# STAFF REPORT

## REGIONAL CENTER HEARING EXAMINER - HIGH IMPACT CASE

<b>Case Number</b>	2024-REG-046
<b>Address (approx.)</b>	238 and 240 South Pennsylvania Street
<b>Location</b>	Center Township, Councilmanic District # 18
<b>Petitioner</b>	Boxcar Development, LLC., by Timothy E. Ochs
<b>Zoning</b>	I-3 (FF) (TOD) (RC); CBD-2 (FF) (TOD) (RC) (pending)
<b>Request</b>	Regional Center Approval for provide for a three-story entertainment venue.

**SITE PLAN - SCALE: 1" = 20'-0"**

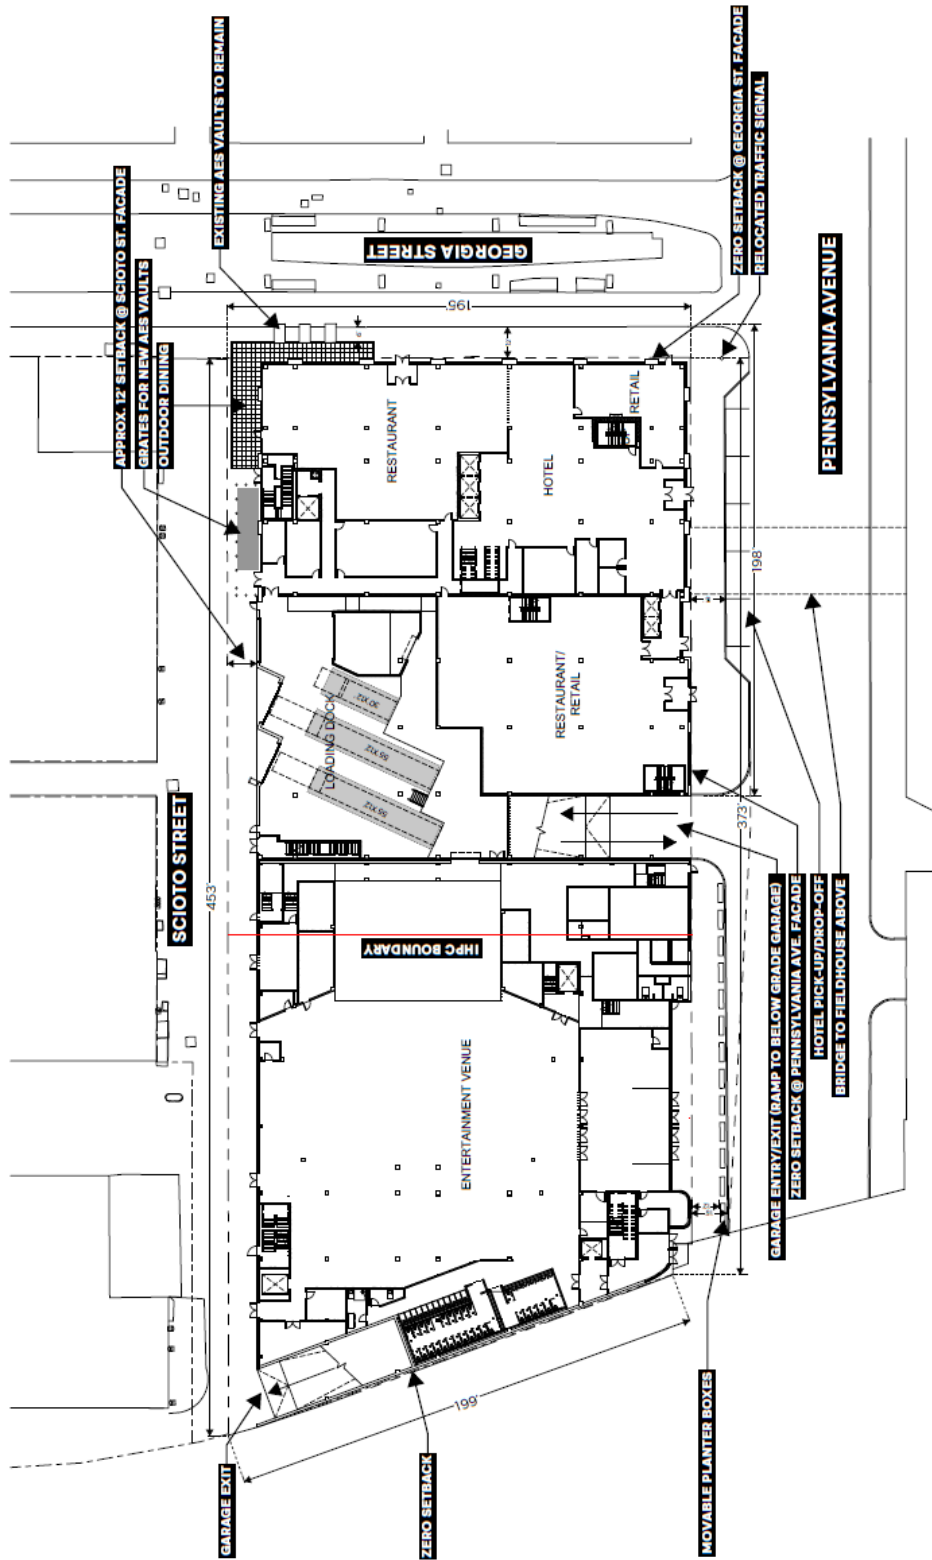
granted by the IHPC on September 4, 2024, the IHPC reviewed the portion of the entertainment venue within their jurisdiction. The majority of the entertainment venue would be within the Regional Center. The proposed building material would be mostly brick, clear vision glass, and metal, with a canopy over the entrance to the facility. A large area of the brick façade would not have openings. This area would include a design within the façade, which would help break up the blank façade. The site plan indicates a number of movable planter boxes along the street. No details of these planter boxes were submitted to the file.

Option 1B, with a mural – West (rear) elevation

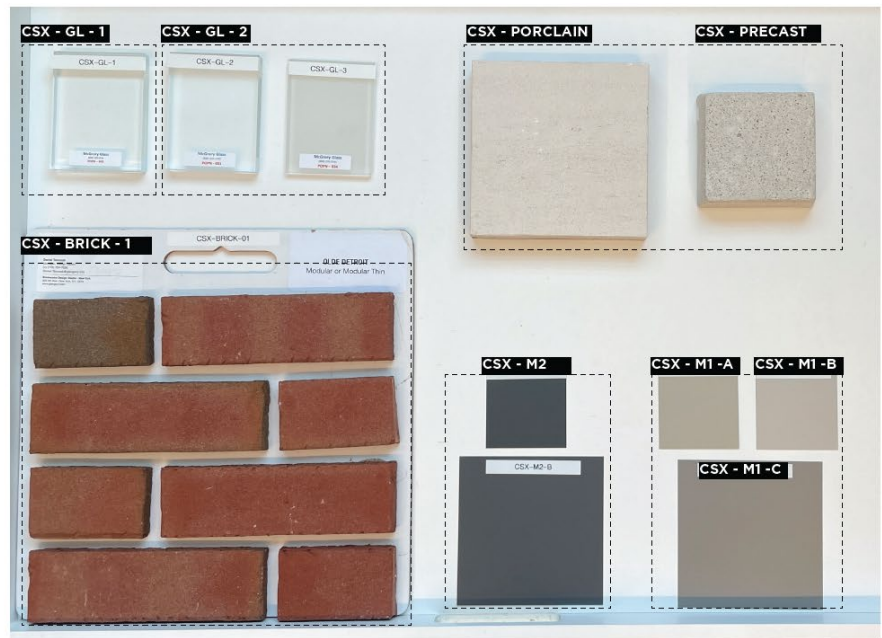
<p>ADV</p>	<p><i>US 1.5.1 – Support for the arts is recommended to be integrated into the design of every new public and new commercial project with a floor area over 50, 000 square feet in size or having a construction cost of over \$1,000,000.</i></p>	<p><b>Satisfied with Option 1B</b></p>
<p>ADV</p>	<p><i>US 1.5.2 – Public Art is recommended to be integrated with all new public institution and government construction projects greater than \$1,000,000 in value. Public Art is art that is located on public property and/or integrated with public construction projects. Public Art can include all forms of original works of art, exterior or interior, which are accessible to the public during normal hours of operation.</i></p>	<p><b>Satisfied with Option 1B</b></p>

REQ	<i>US 1.5.3 – All permanent installations of art located in the Public Sphere or Quasi-Public Sphere shall be constructed of durable materials, not interfere with public safety, and be free of advertising. The installation shall provide access for as many individuals as possible (the provision of access for the mobility, hearing, and vision impaired is encouraged), consider public safety and liability issues; consider vehicular and pedestrian traffic patterns; consider the relationship to architectural and natural features, landscape design, environmental impact, and future plans for the area. Petitioners are encouraged to develop a long-term maintenance program for all permanent installations.</i>	<b>Satisfied with Option 1B</b>
REQ	<i>US 1.5.4 – All temporary installations of art shall not interfere with public safety and be free of advertising. Petitioners are encouraged to develop a long-term maintenance program for any such installation that uses recurring temporary or non-durable elements (such as flags or banners).</i>	<b>Satisfied with Option 1B</b>

ADV	<i>US 1.5.5 – Large scale installations of landscaping (environmental art), urban graphics or art consisting of dispersed components are encouraged. Projects will be reviewed for compatibility with these guidelines.</i>	<b>Satisfied with Option 1B</b>
